CHIEF JOSEPH DAM
DISSOLVED GAS ABATEMENT PROJECT

FINAL ENVIRONMENTAL ASSESSMENT
and
FINDING OF NO SIGNIFICANT IMPACT

June 2000

Seattle District

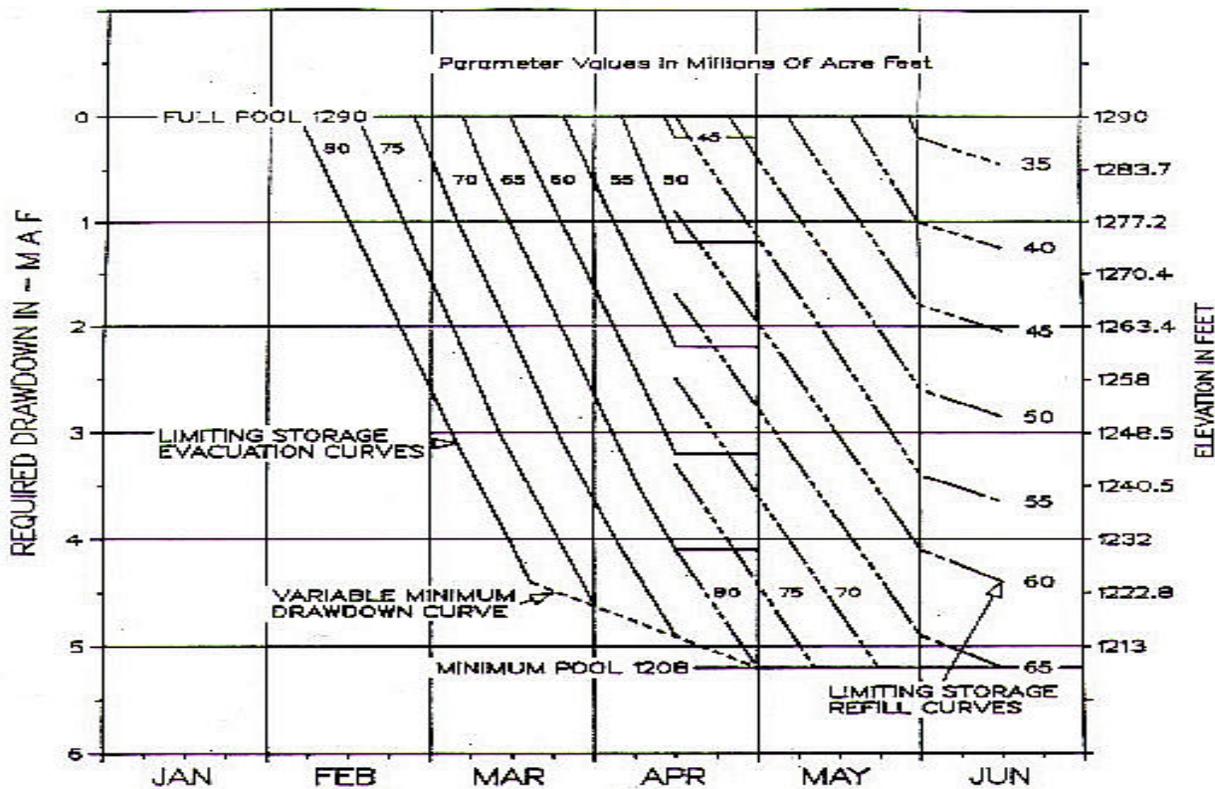
- ⑦ → Page 11. Figure 2.1.2-1 The flood control rule curve for drafting at GCD is presented in graph form. This graph should be more thoroughly explained. Understanding this curve is important to understanding operational requirements and practices at GCD. Further, this curve appears to be a baseline condition assumed in the alternatives evaluated in the EA. To understand the alternatives described in the EA the reviewer should understand Figure 2.1.2-1.

- 7 Additional information has been incorporated into the caption of Figure 2.1.2-1 to explain Grand Coulee flood control operation.
- 8 These alternatives were rejected because it was determined that they are far outside of the scope of this study. The 1998 Biological Opinion for salmon and steelhead tasked us with focusing on Grand Coulee and Chief Joseph. While we considered many alternatives in our Initial Appraisal Report (USACE, 1998b), we were refocused on the two dams that we can affect. To describe operation of Columbia River flood control would be an enormous effort that is also far outside of the scope of this study.

Figure 4.5.2-2. Daily average observed values for spill and outflow temperature at Chief Joseph Dam in spring 1997 (Univ. of Washington, 2000).

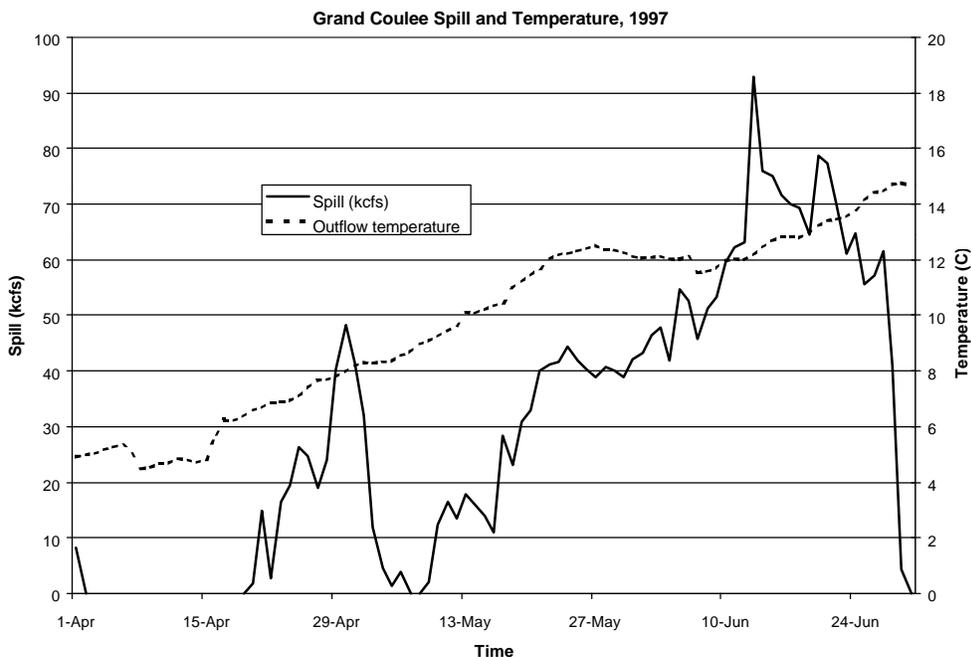
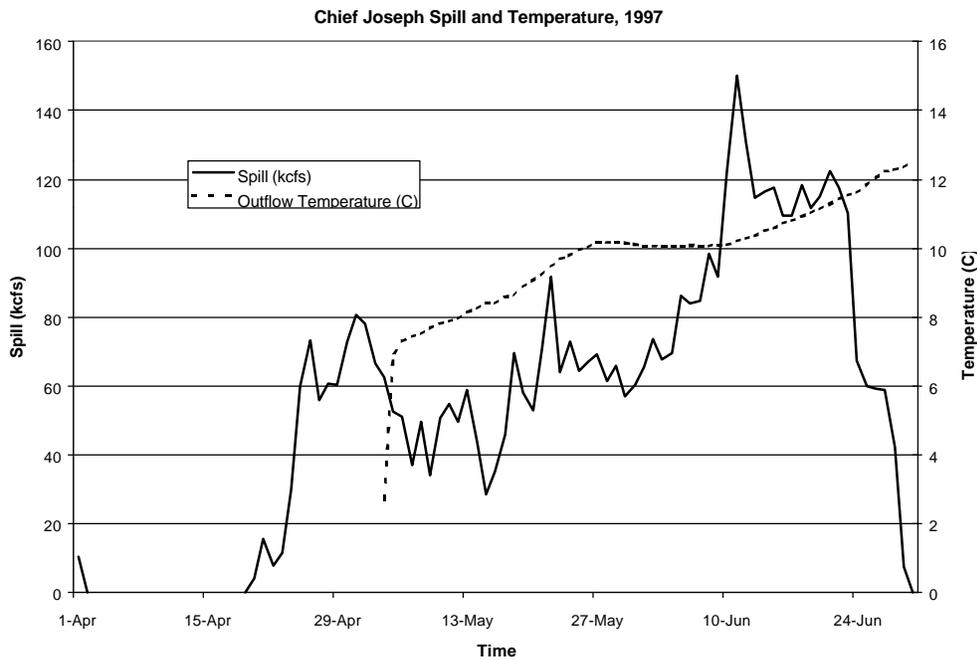
- 25 { → Page 27. Section 4.5.2 Temperature. Paragraph two of this section describes the relationship between spill and outflow temperature. Figures 4.5.2-1 and 4.5.2-2 graph spill and outflow temperature for the two dams for the period April 1 through the end of June, 1997.
 The temperature graphs show that temperatures below CJD are consistently lower than outflow

(26) → Page 28. Figure 4.5.2-2. This figure shows spill volume (and outflow temperature) at CJD during spring 1997. The spill flow shown generally exceeds spill at GCD by as much as 55 kcfs. Under similar flow conditions, will the preferred alternative produce higher spill flows at CJD? Under 7Q10 flow conditions, what are the anticipated spill flows at both GCD and CJD? At 7Q10, what are the anticipated TDG levels below both GCD and CJD? These questions recur while reviewing the EA and should be addressed.

Figure 4.5.3-2. Observed flow and dissolved gas conditions in spring 1997 for water entering Lake Rufus Woods.

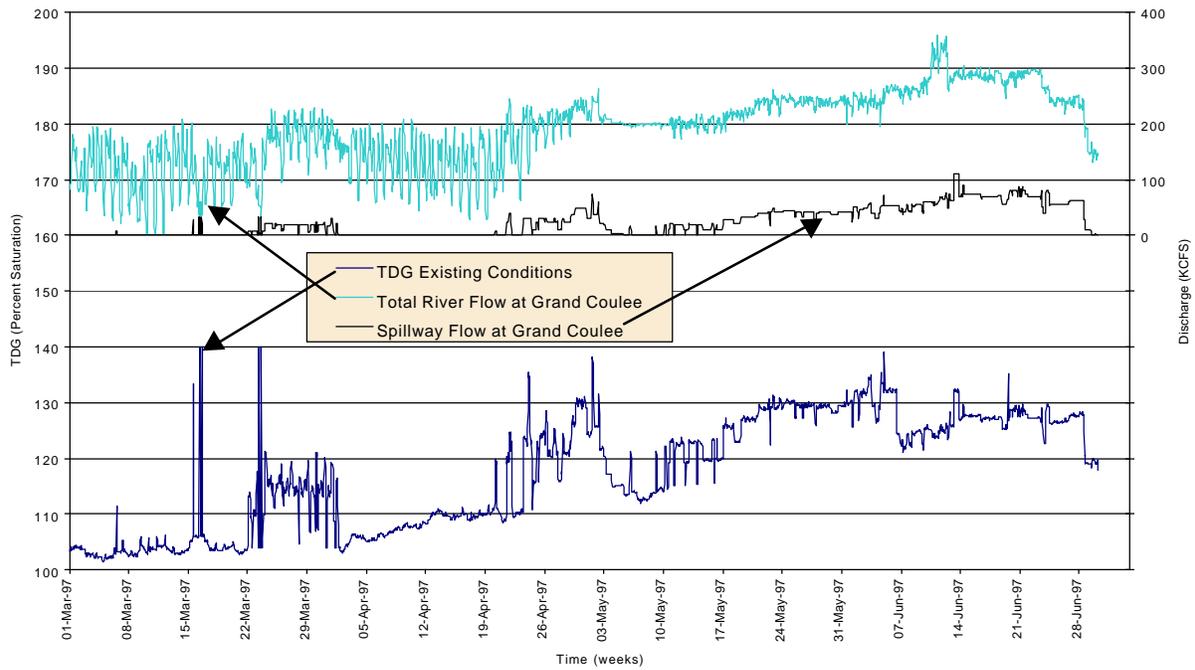
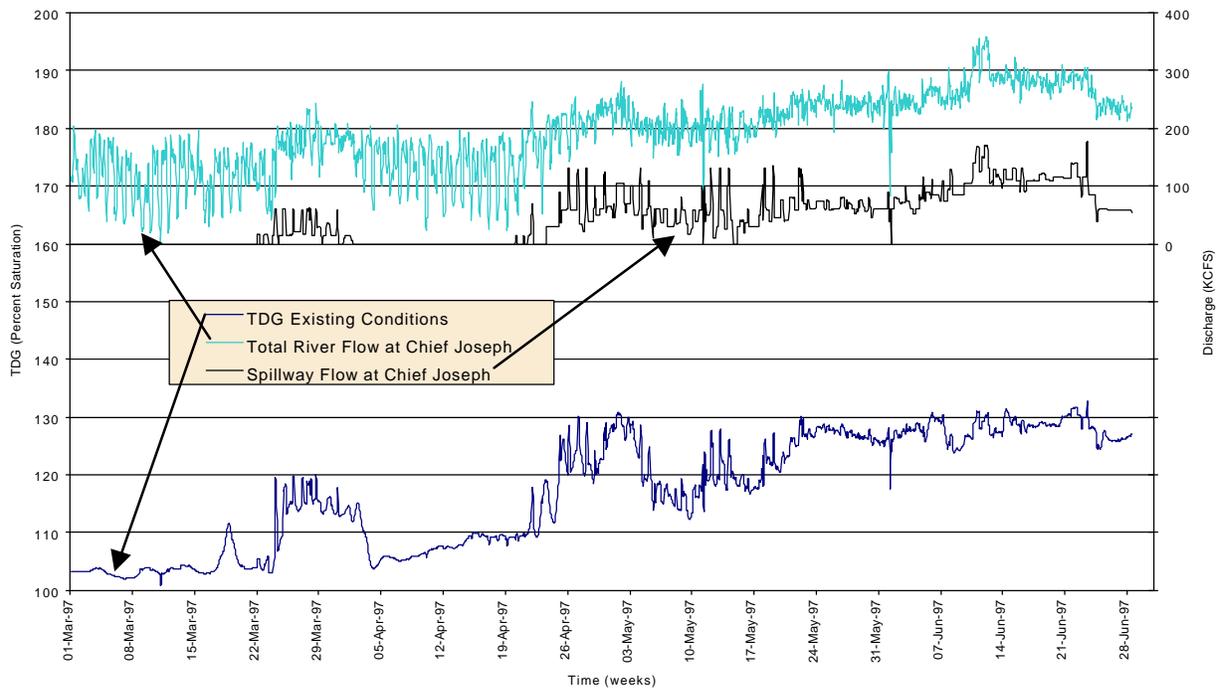
(27) → Page 30. Figures 4.5.3-2 and 4.5.3-3. These figures show river flow, spillway flow, and TDG levels at/below GCD and CJD, respectively. It appears from these figures that spill flow at CJD, compared to GCD, can be double that shown in figure 4.5.2-2. These figures appear to show that CJD spills up to 100 kcfs more than GCD whereas figure 4.5.2-2 seems to show a maximum difference of about 55 kcfs for this same period. These differences may be important in projecting TDG levels generated under the preferred alternative and should be explained. Since power generation is to be maximized at GCD and spill maximized at CJD under the preferred alternative, are spill flows at CJD anticipated to be higher than those recorded in the past? What spill is anticipated under high flow, low power demand scenarios for both GCD and CJD?

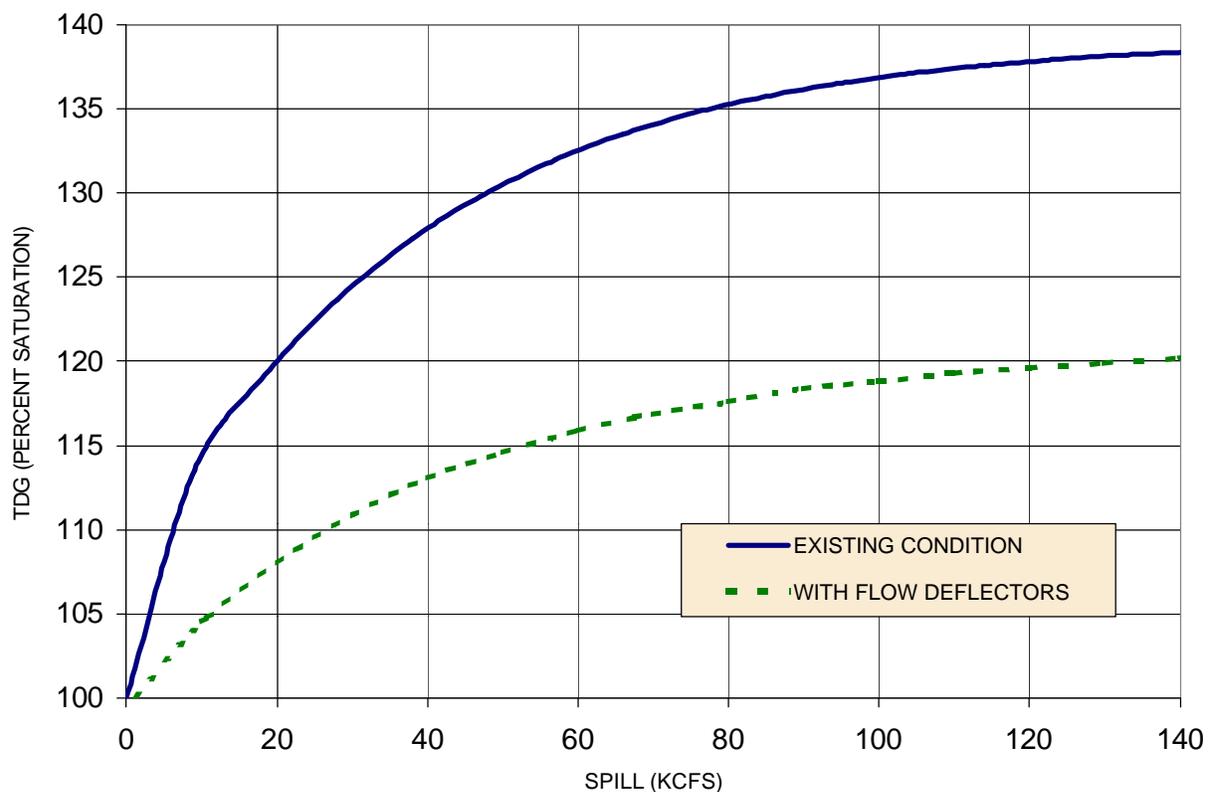
30 } → Page 39. Figure 5.5.3-1. TDG production curves for CJD with and without deflectors. This figure may be misleading when considering the benefits of deflectors and the preferred alternative. The curves appear to represent projected TDG concentrations below CJD as a function of increasing spill flows *given a forebay concentration of 100% TDG*. What would the curve look like if the forebay concentration were, say 105%? Are these curves intended to be predictive of TDG concentrations downstream of CJD based on spill volume? The conditions under which this graph is intended to show CJD additions to TDG and what those additions represent is unclear to the reviewer and have led to different interpretations in this office. The graft should be better explained.

14. Page 39, Figure 5.5.3-1: This figure has been oversimplified. It should include tailwater elevation, discharge, and deflector submergence, and show exceedence curves that indicate the preferred operating range. It is probably not necessary however, for the EA to include a description of each flow zone.

- 30 Text has been modified to provide more information. Gas production shown in Figure 5.5.3-1 from the spillway only is largely independent of forebay gas levels.

The Corps' Dissolved Gas Abatement Study, Phase II, 60% report (USACE, 1999) covers this in more detail. The gas levels in subsequent figures represent a mixed river condition that takes into account TDG in the forebay via generation flows. The curves in Figure 5.5.3-3 represent the entire March-June 1997 period. At times, there was no spill, and early in the season, TDG coming from Canada was low. The low values represent what was passed through the powerhouses of both projects.

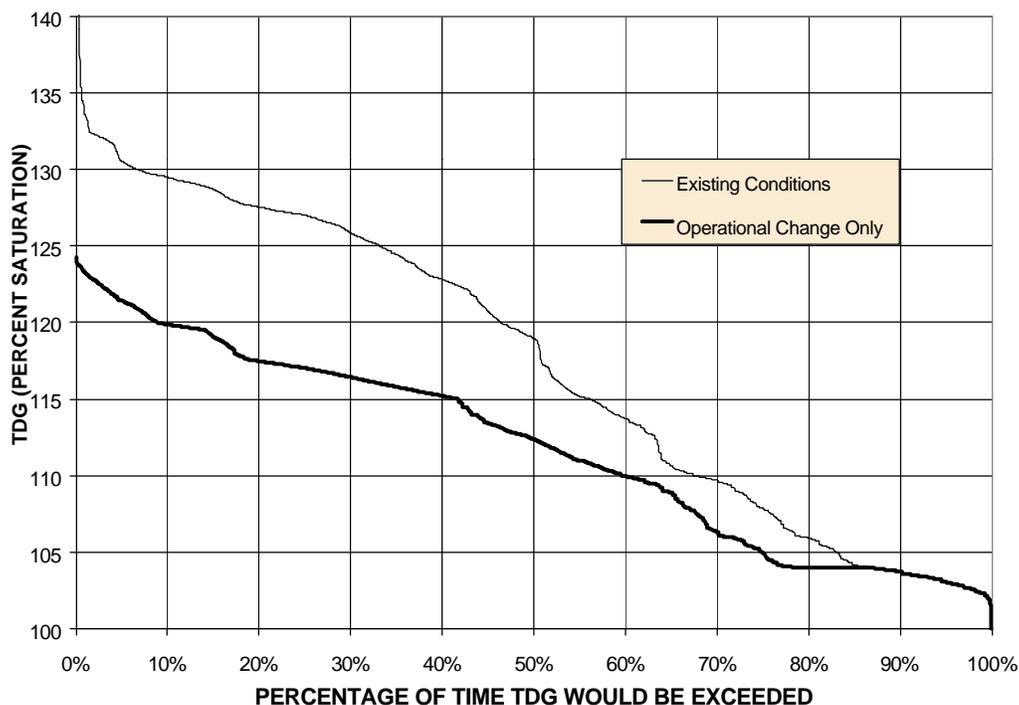
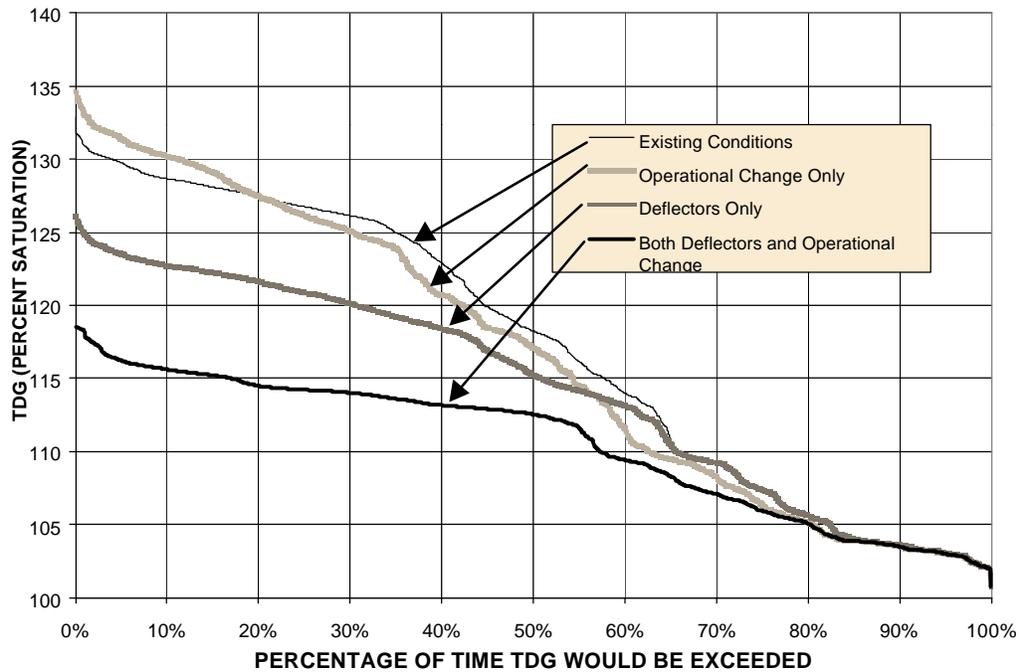
31 } → Page 40. Figures 5.5.3-2 and 5.5.3-3. These figures represent the projected percentage of time various TDG levels would be exceeded below GCD and CJD, respectively, given flows of March through June, 1997, under the preferred alternative. These figures show that the WQS of 110% is projected to be exceeded below GCD 60% of the time and about 58% of the time below CJD (given 1997 spring season flows). The actual flow values used for these calculations need to be stated since flow during the 1997 season is shown to be as high as 350 kcfs in Figures 4.5.3-2 and 4.5.3-3 and as low as 0 kcfs. It appears that flow is included as a variable based on 1997 data but this is not clear from the figures or narrative. Since the WA WQS is based on the 7Q10, figures for projected TDG concentrations should be presented using this flow.

32 } The projections in these two figures seem to be at odds with the results shown in the preceding Figure 5.5.3.-1. In that figure, a forebay concentration at CJD at or above 105% combined with an operational preference for spill at CJD suggests that TDG levels below CJD will be higher and will occur more frequently, with TDG levels near or exceeding 110% at spill flows of 10 kcfs and exceeding 120% at spill flows of about 65 kcfs. This apparent contradiction in projected TDG levels under the preferred alternative needs to be addressed.

15. Page 40, Figure 5.5.3-3: The lines are not distinguishable on this graph.
16. Page 41, 2nd paragraph: It is unclear why the operational alternative results in a higher TDG level than the no-action alternative. Please explain.

Figure 5.6.1.1-1. Rock Island Dam 5-year (1995-99) average smolt index values, and Lake Pateros 1997 modelled dissolved gas values for each alternative. Spill stops in June, and though dissolved gas levels are not shown here, they are the same for all alternatives following that cessation.

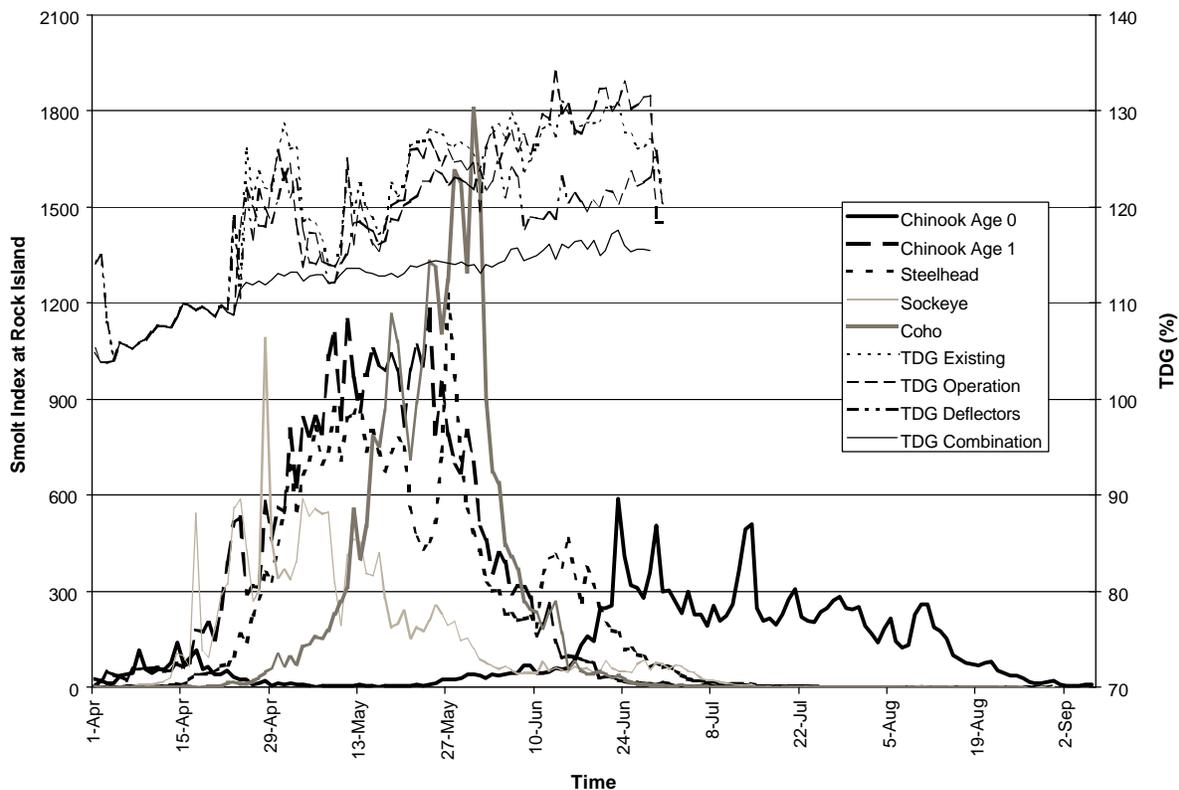
38 → Page 46. Figure 5.6.1.1-1. Rock Island 5-year average smolt index values. The various curves for TDG should be extended through the year so that the reviewer can compare TDG, summer flows, and flow augmentation episodes with smolt migration.
